**Inspection Report
420-426 Pitt Street, Haymarket**

Council investigation officer Inspection and Recommendation Report
Clause 17(2), Part 8 of Schedule 5, of the Environmental Planning and Assessment
Act 1979 (the Act)

**Re: INSPECTION REPORT
'MOSIAC'
420-426 PITT STREET, HAYMARKET ("the premises")**

Re: **INSPECTION REPORT
MOSAIC
420 PITT STREET HAYMARKET ("the premises")**

Figure 1 - Example Boost Pressure signage.

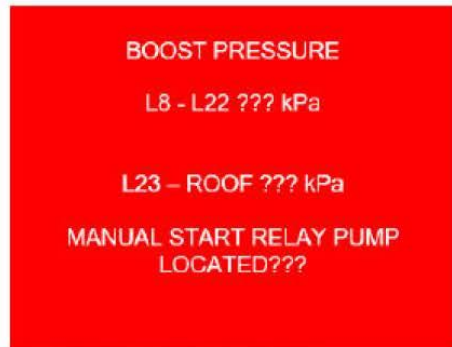
Boost and test pressure signage is not installed at the hydrant booster cabinet to advise the fire brigade of boost pressure to provide 700 kPa at the most hydraulically disadvantaged hydrant in each pressure zone or the required pressure for the relay pumpset.
 - C. The fire hydrant booster is in Campbell Street on the southern end of the building. The booster comprises an 'H' pattern booster for carpark 1 to Level 7 and a high-rise boost inlet connection.

- d. Multiple boost and test pressure signage should be installed at each boost inlet connection for each pressure zone as per Item 1A.B. above. The Zone 2 and 3 boost inlets connection should contain two pressures (see Figures 1 and 2).

- a. In this regard, the installed signage must be water and fade resistant, in accordance with Clause 7.10.1 of AS2419.1-2005. Multiple boost and test pressure signage should be installed at each boost inlet connection for each pressure zone as per Item 1A.B. above. The Zone 2 and 3 boost inlets connection should contain two pressures see figures 1 & 2 below as recommended by FRNSW.
